**Meeting of the Central Valley Flood Protection Board  
February 26, 2016**

**Staff Report**

**Union Pacific Railroad Bridge (No. 145.57) Replacement**

Consider approval of Permit No. 19062. (Attachment B)

FIGURE  
F-4

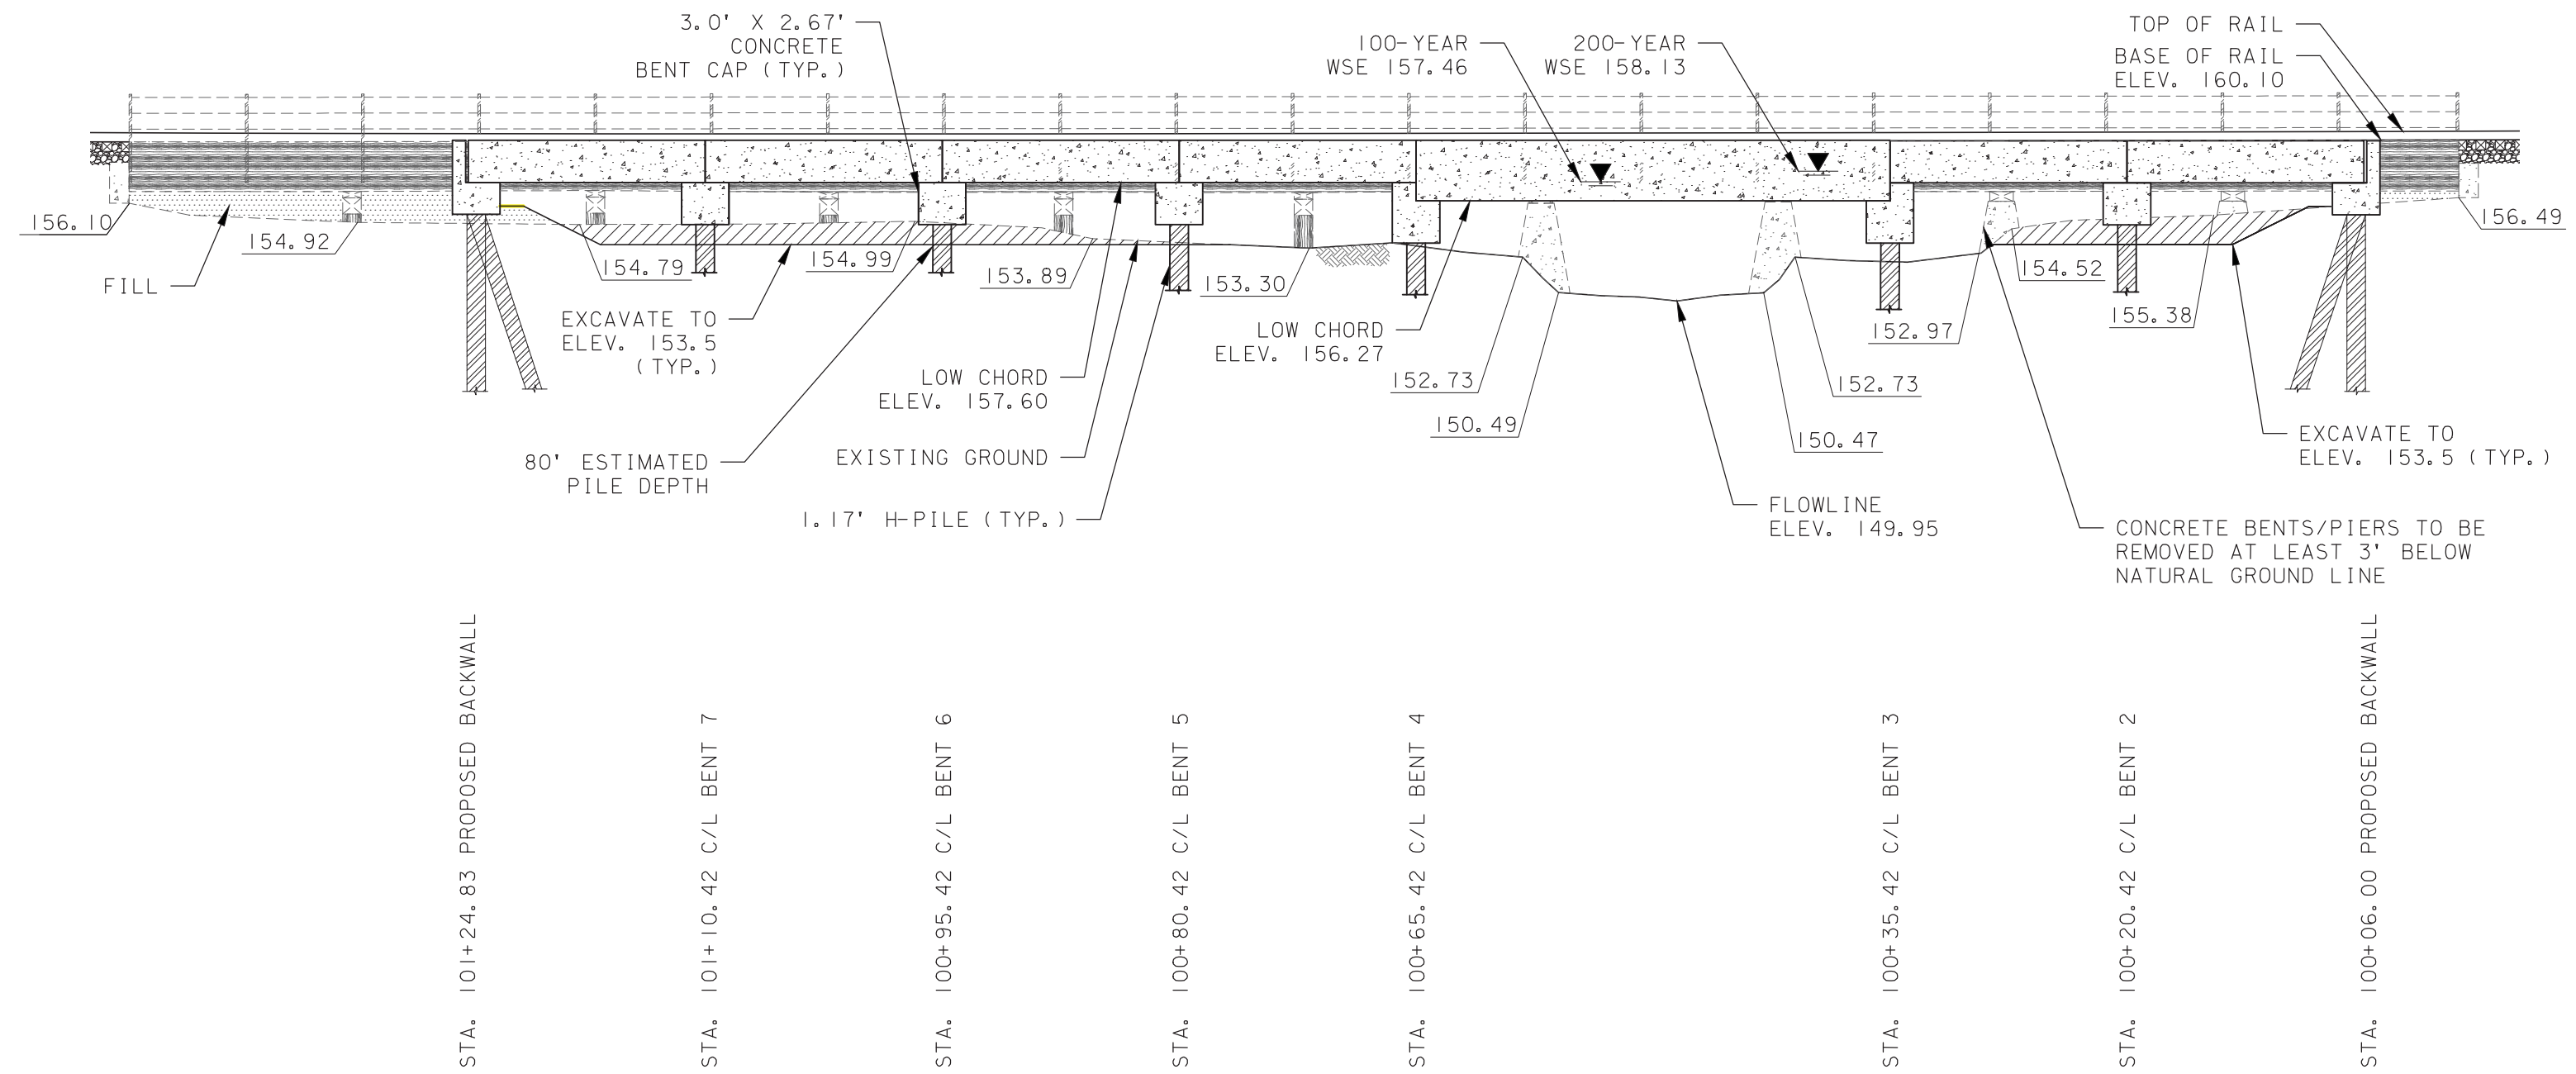
The majority of the replacement bridge will be .83 feet above the existing elevation, with one 30 foot span that will be .52 feet lower than the existing bridge. The applicant has stated that the lower elevation span is needed to provide adequate structural stability for the increases in railroad tonnage. However, this proposed 30 foot long concrete box girder design also will result in one less bent within the channel, thereby reducing the risk of debris accumulation along the upstream face. The overall elevation increase, combined with one less bent within the channel, will result in approximately 27% more flowage area under the new bridge. This increase is reflected in a water surface elevation decrease on the upstream face of the new bridge.

Bridge 145.57 crosses Canal Creek which primarily conveys flows from Castle Dam. The 100-year design discharge of 970 cfs was taken from the Caltrans Study for Canal Creek along the newly constructed Atwater-Merced Expressway/State Route 99 Interchange Project, a short distance upstream. The project was designed to have no rise in the water surface elevation (WSE) during both 100 and 200- year events. Due to the decrease in bents, excavation underneath the bridge, and a raise in the low chord along the approach spans, the proposed bridge will have a total opening area that is 27% greater than the existing conditions. The WSE for existing conditions for a 100 year event is 157.71 feet. The WSE with the proposed project is 157.46 feet, a decrease of 0.25 feet (Attachment D).

The lowest low chord of the proposed bridge is 156.27 feet and the WSE for the proposed project is 157.46 feet, resulting in the low chord being submerged 1.19 feet. However, because this is a replacement railroad bridge there is no requirement of clearance above the design flood plain. Therefore, the hydraulics of the proposed project meets Title 23 standards.

Based upon the above, Board staff, in consultation with legal counsel, has recommended and the Executive Officer has agreed that there is no legitimate reason for the application of Section 128(a)(16) requiring replacement railroad bridges to have the soffit members no lower than those of the replaced bridge and thus, has waived that standard in this particular instance pursuant to the authority in Section 11(d).
